SUMMARY REPORT OF PHASE I RCRA CLOSURE ACTIVITIES FOR TANK AND ANCILLARY EQUIPMENT SYSTEM #7 IN BUILDING 771 - TAH-004-99

Phase I Summary Report of
RCRA Closure Activities for
Tank and Ancillary Equipment System #7
in Building 771

Figure 6: System #7 - Modified Drawing of Termination Details, continued

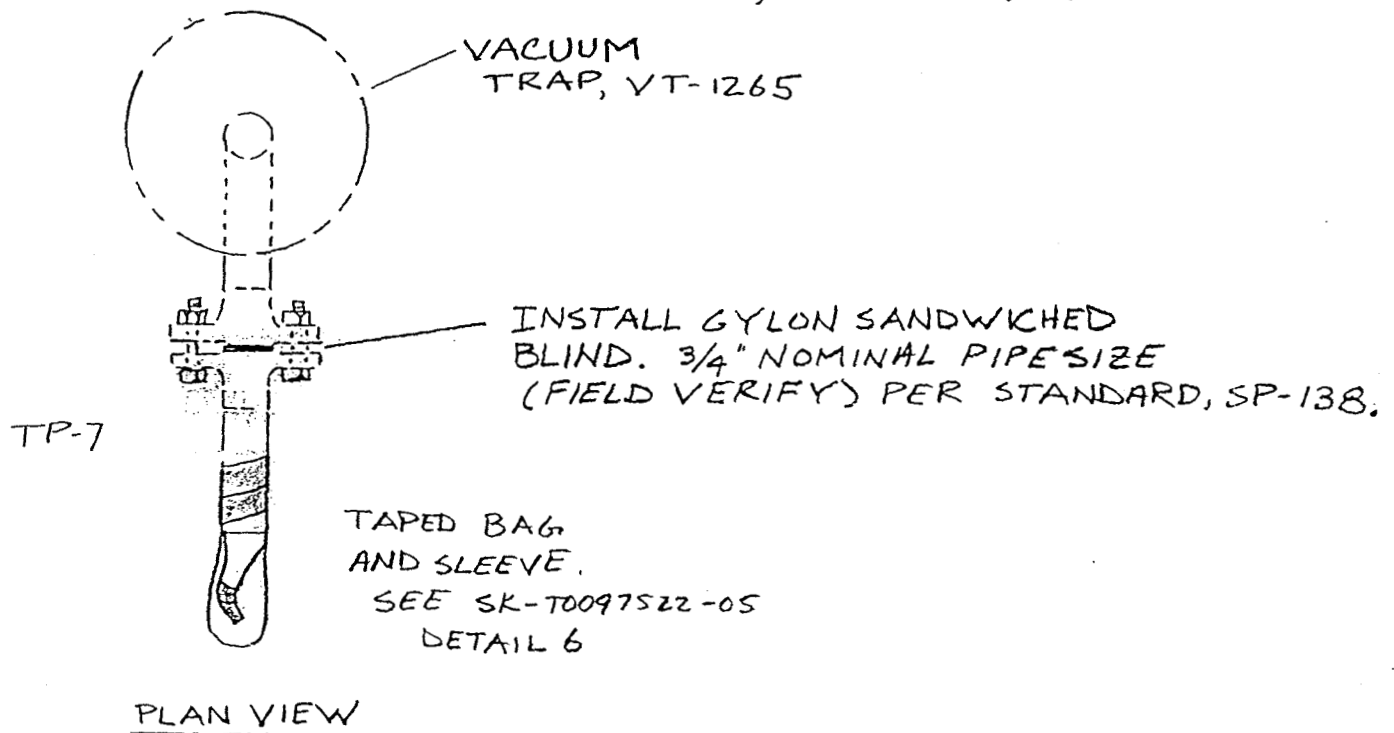
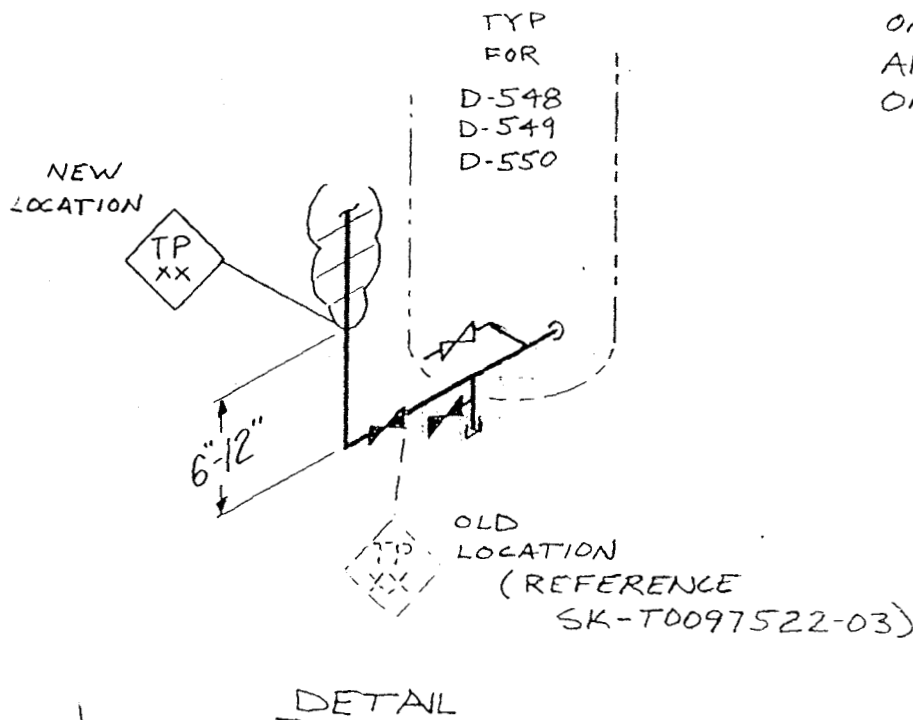
CHANGE THE LOCATION OF TP-14, TP-15, AND TP-16 AS SHOWN ON THIS SHEET. SLEEVE, TAPE, AND BAG THE PIPE AS SHOWN ON SK-T0097522-05, DETAIL 6.

Figure 6: System #7 - Modified Drawing of Termination Details

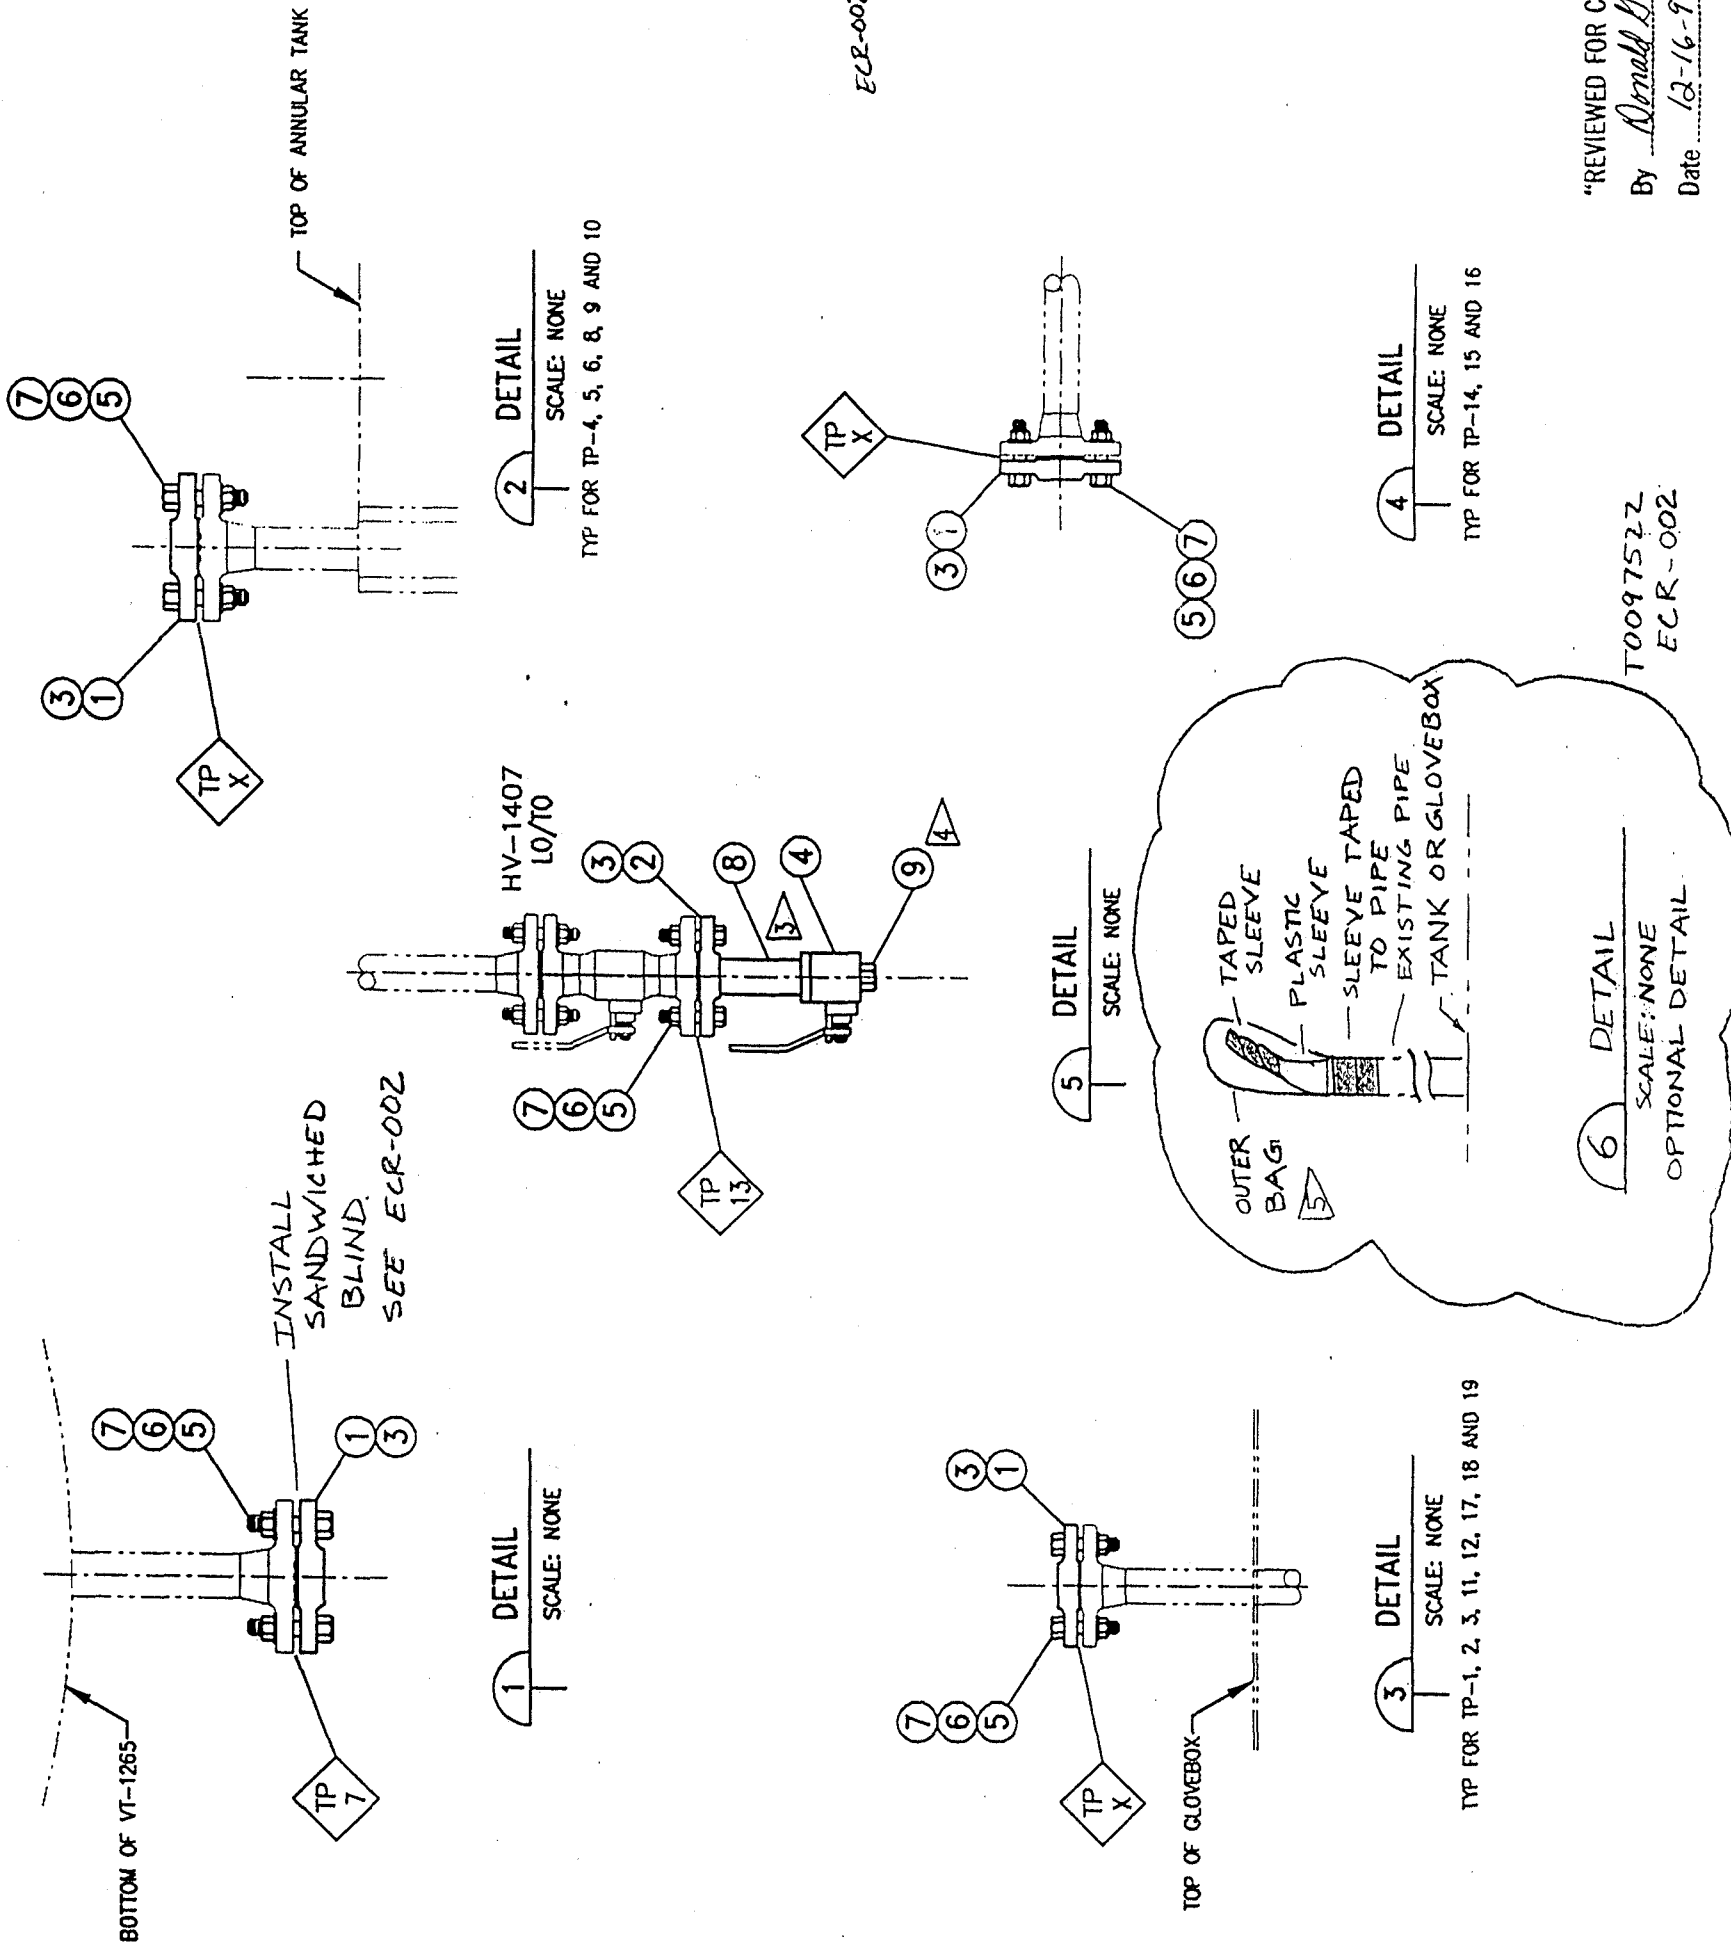
Piping removal was accomplished by using a 4-wheel cutter inside a sleeve or T-sleeve to cut the pipe wall until separation was almost achieved. The cutter was then removed, the sleeve was taped, the pipe was manually separated, and the sleeve was closed in a pigtail formation to secure all pipe ends. Short pipe stubs were left at Termination Points (TPs) instead of blind flanges. The containment method used for pipe stubs is illustrated in the modified Figure 6, which is attached.
